Final Drainage Report for Hillpointe Apartments at Peterson

HR Green Project No: 2502477

PCD File No. PPR2613

Hillpointe Apartments at Peterson
100-Yr Storm w/ Tailwater - Main A

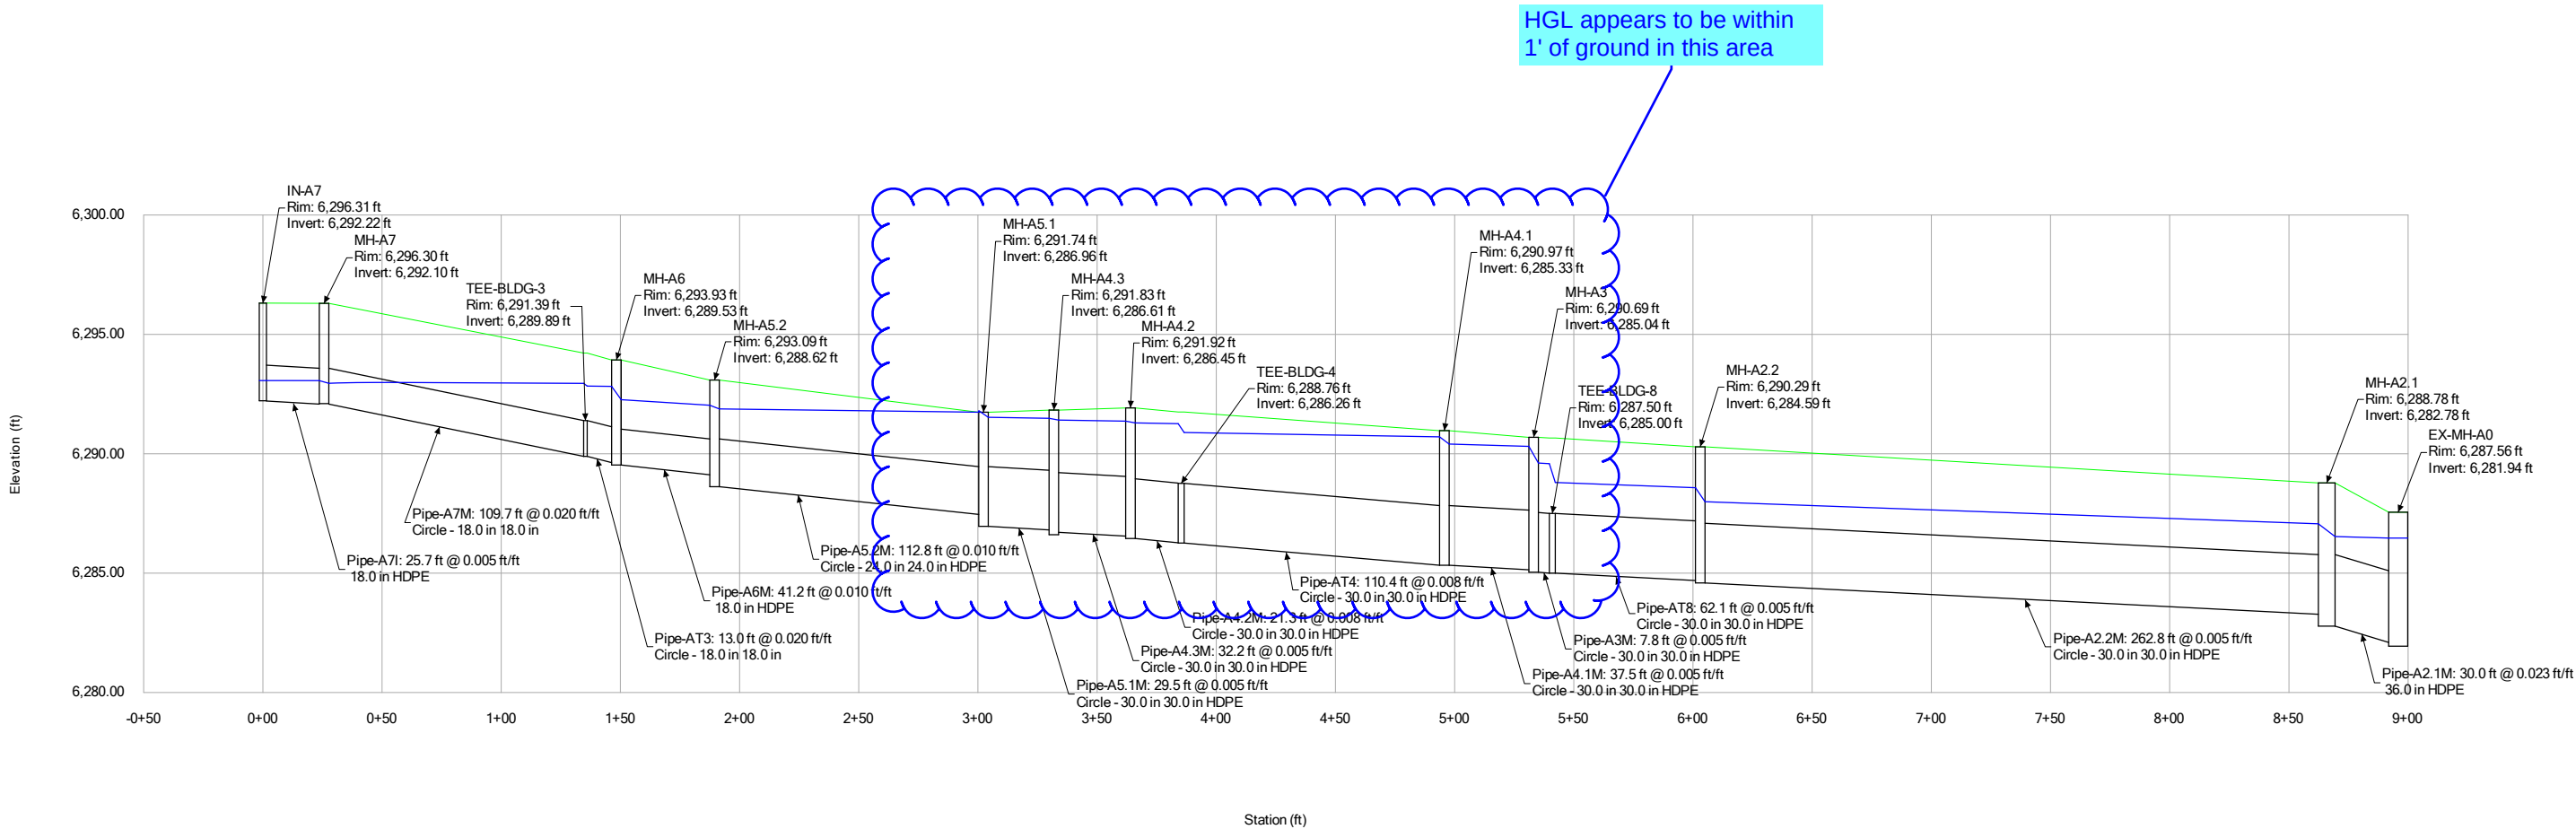
Provide slope for pipes

It appears highlighted pipes may have been put in backwards. Such as inverts for inlets (high/start end) match with MH inverts on CD's (Low/stop end)

See CDs for lengths that do not match with design

Hillpointe Apartments at Peterson
100-Yr Storm w/ Tailwater - Main B

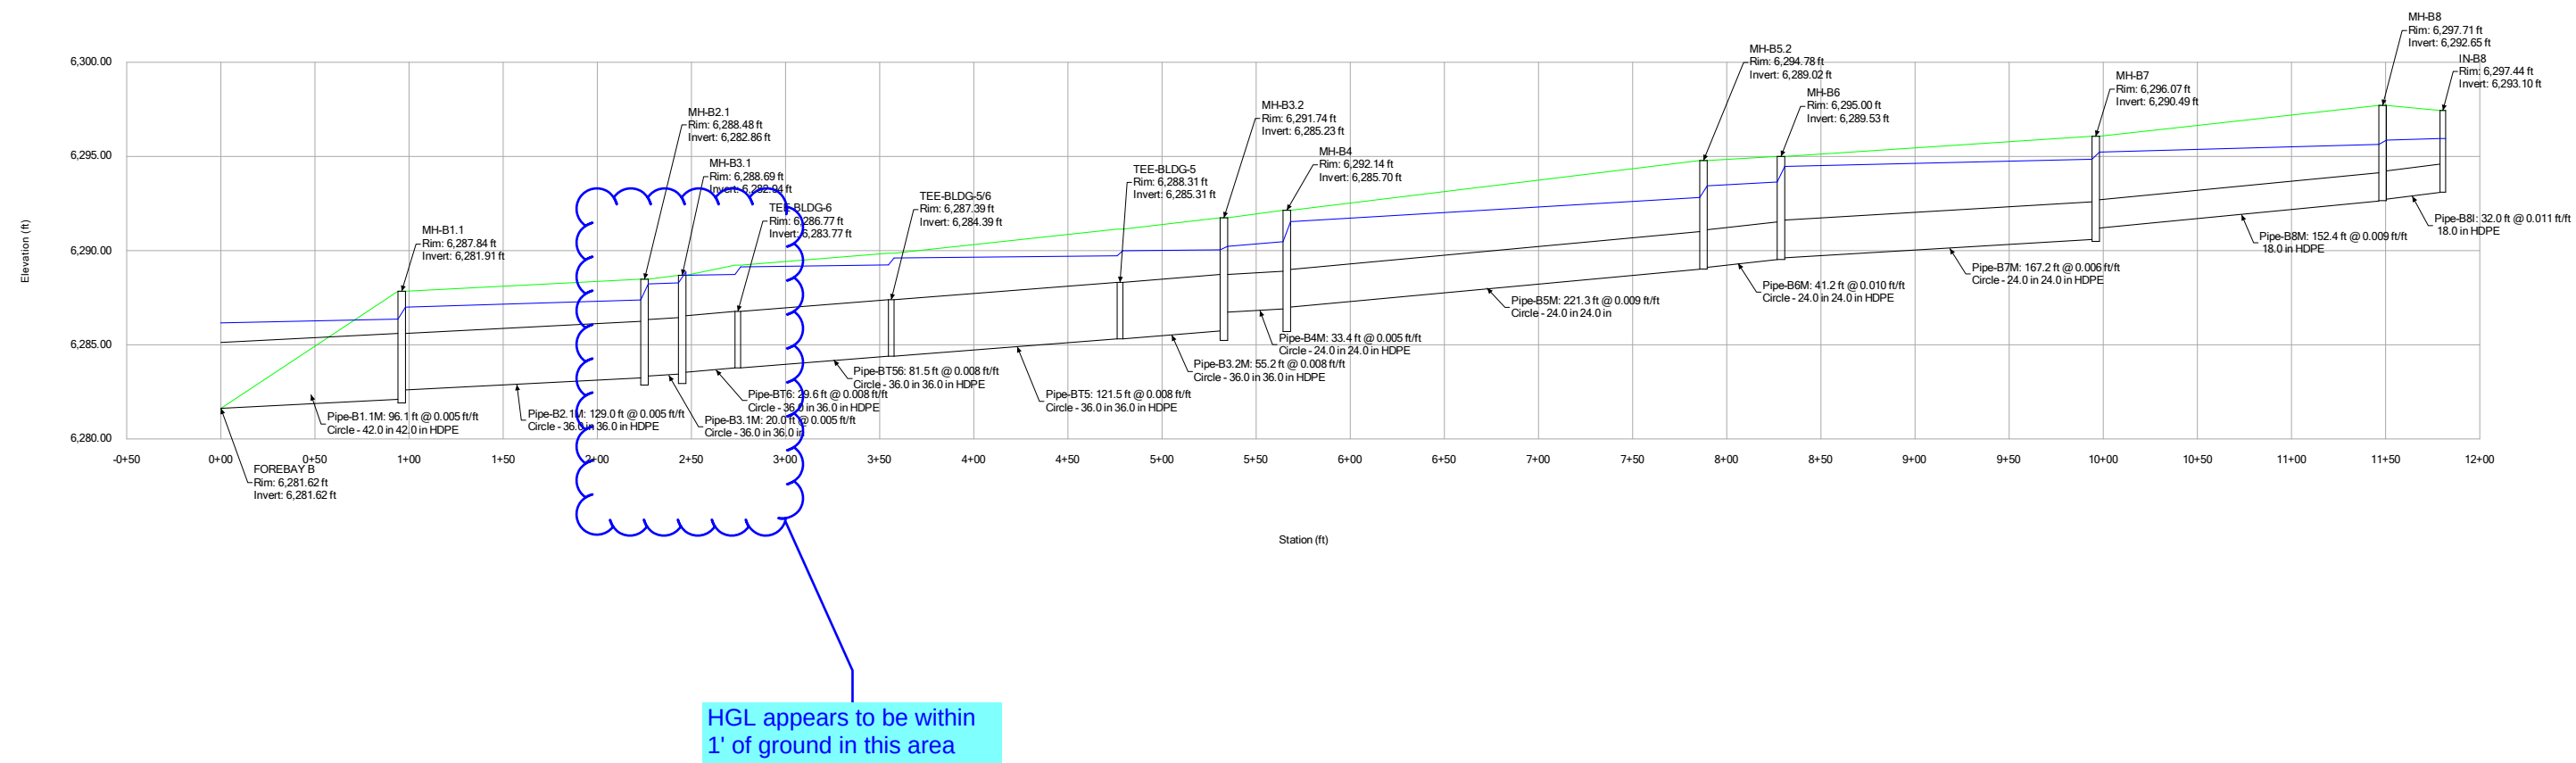
Provide slope for pipes

DETENTION BASIN OUTLET STRUCTURE DESIGN

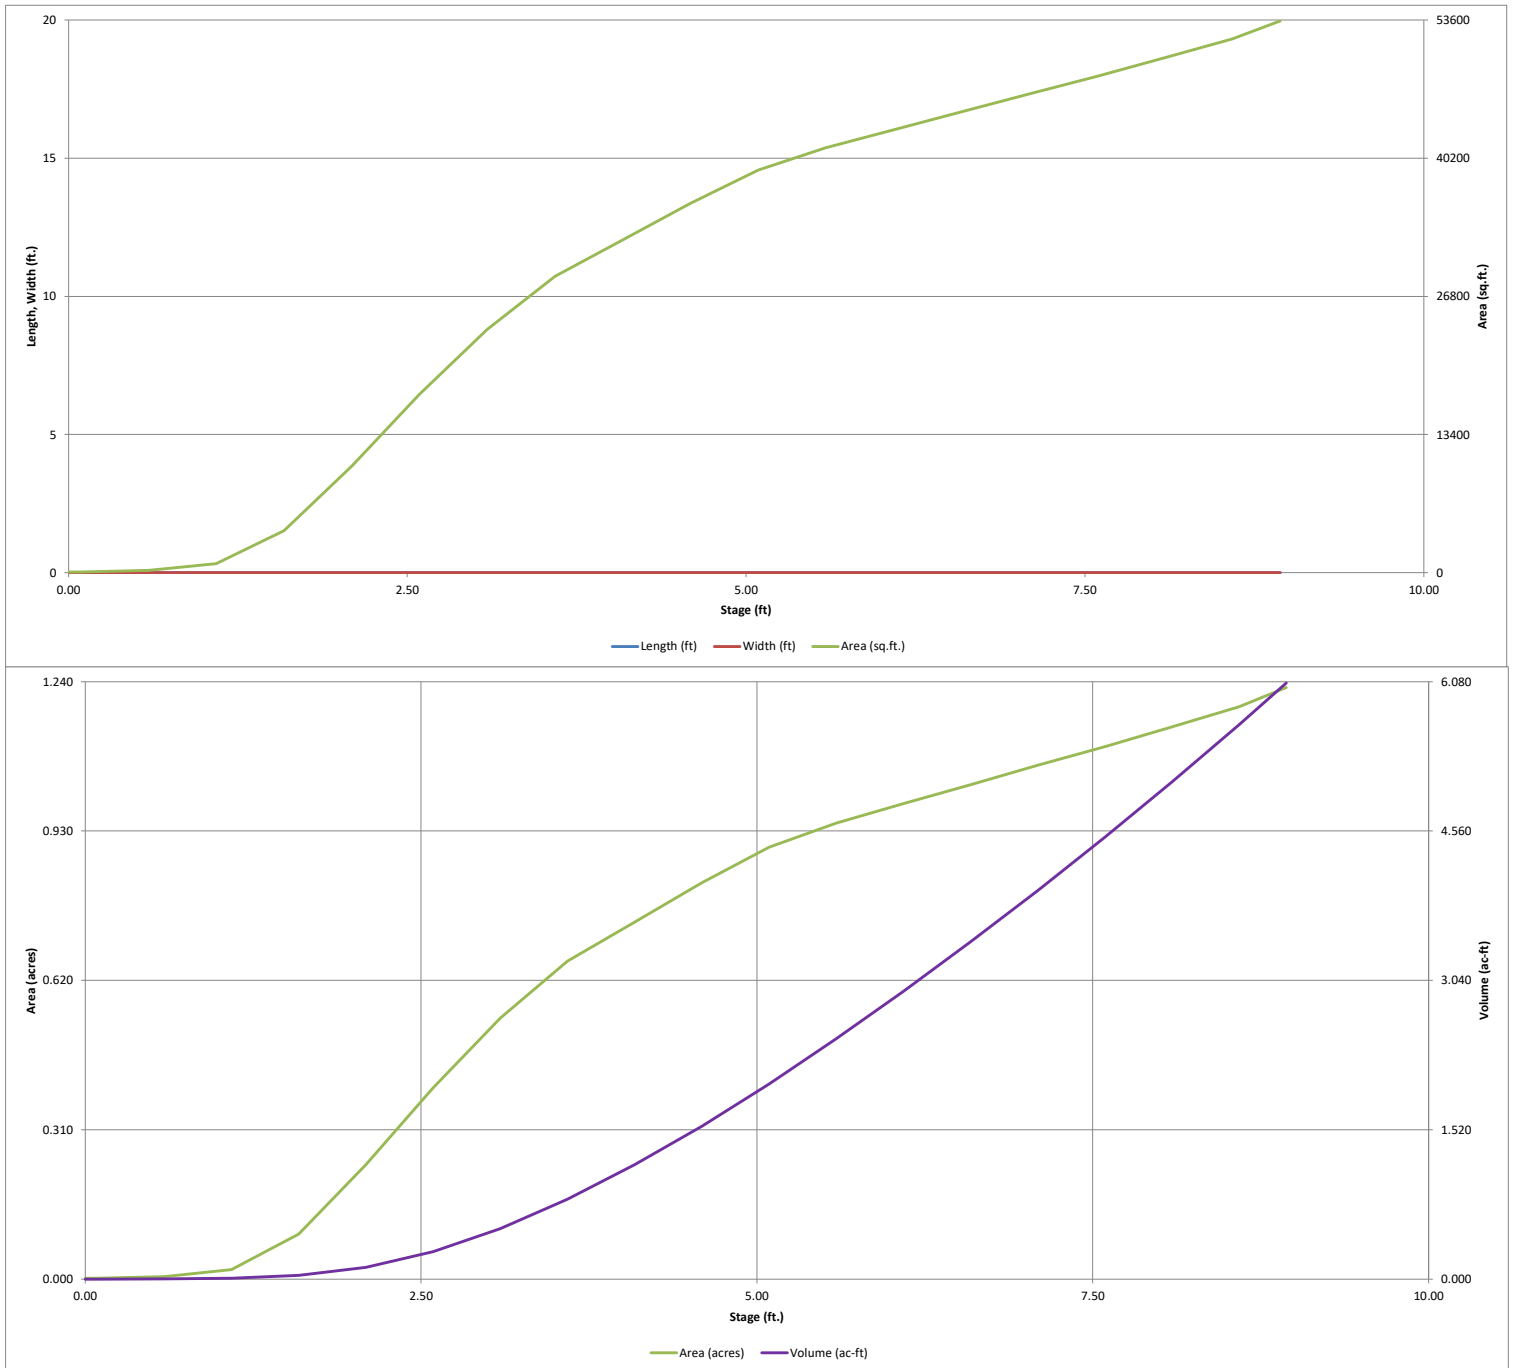
Time to Drain 97% of Inflow Volume (Hours): This does not meet the drain time requirements indicated in Senate Bill 15-212. Please revise accordingly.
